Authorized Field Change

AFC 17911

Subject File: Uptime Improvements

Subject: Update Instrument Cluster, Body Control Module (BCM), Light Control Module (LCM), Switch Pack Modules, Stalk Shifter Module, Auxiliary Battery Interconnect cables, and Aero Bumper Rock Screen.

Figure 5. Battery Interconnect Cables

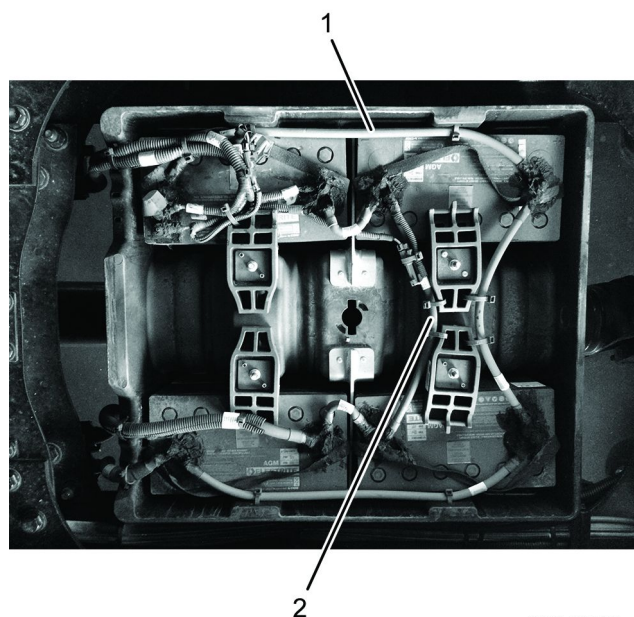
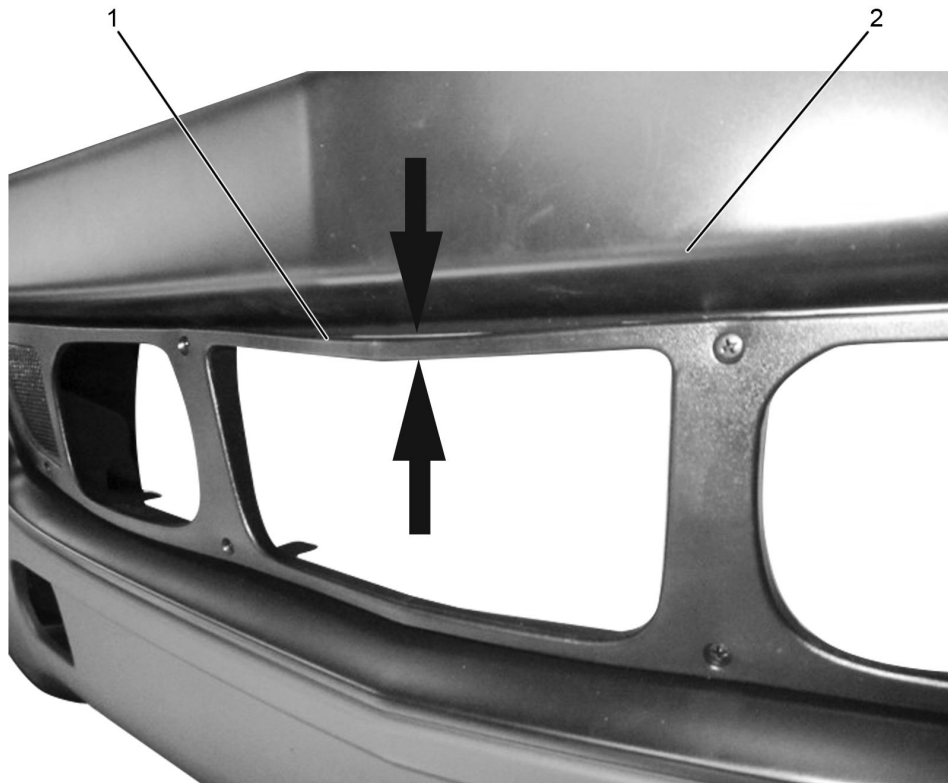
22. Cut tie straps and remove negative battery interconnect cable (Figure 5, Item 2).
23. Cut tie straps and remove positive battery interconnect cable (Figure 5, Item 1).

24. Install new negative battery interconnect cable.
25. Install new positive battery interconnect cable.
26. Using tie straps, secure negative and positive interconnect to same clipping points as cut in Steps 22 and 23.
27. Using a torque wrench, tighten positive battery post nuts to 142 - 177 lb-in (16 - 20 N•m).
28. Using a torque wrench, tighten negative battery post nuts to 142 - 177 lb-in (16 - 20 N•m).
29. Connect ground cable on main vehicle battery.
30. Apply Grafo dielectric grease to positive and negative battery posts.
31. Install battery box cover.
32. Install deck plate if equipped.

Figure 7. Rock Screen Radar Frame with U-Clip Fastener (Bumper Interior)

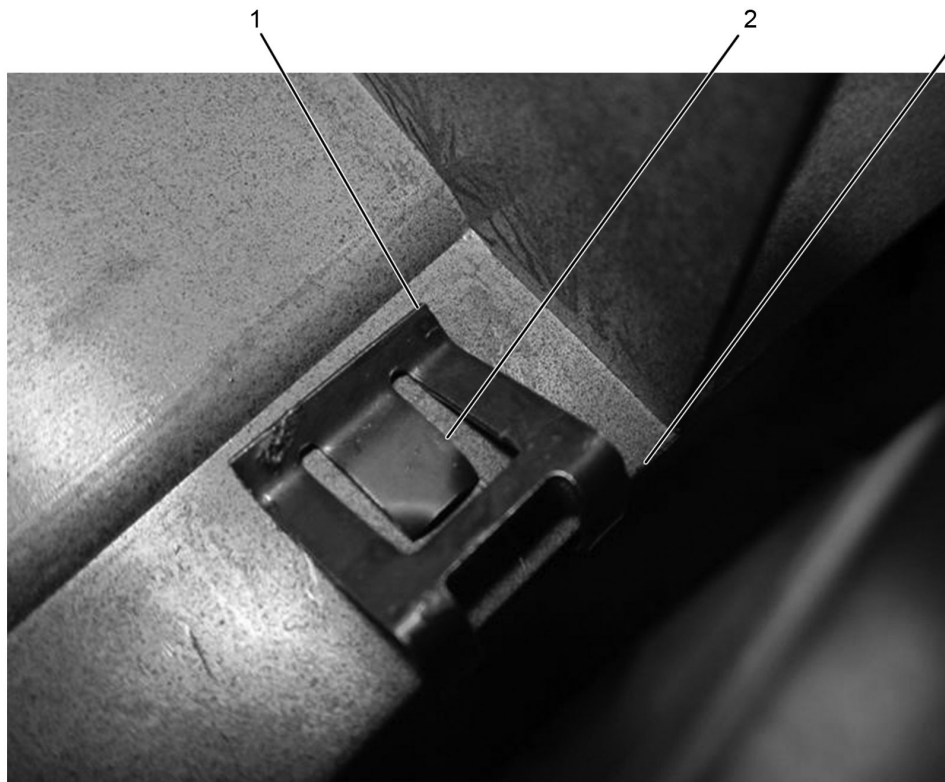
34. Align and install U-clip fastener (Figure 7, Item 2) with retaining tab face up to top center area of rock screen radar frame (Figure 7, Item 1), securing radar frame to inside edge of bumper applique (Figure 7, Item 3).
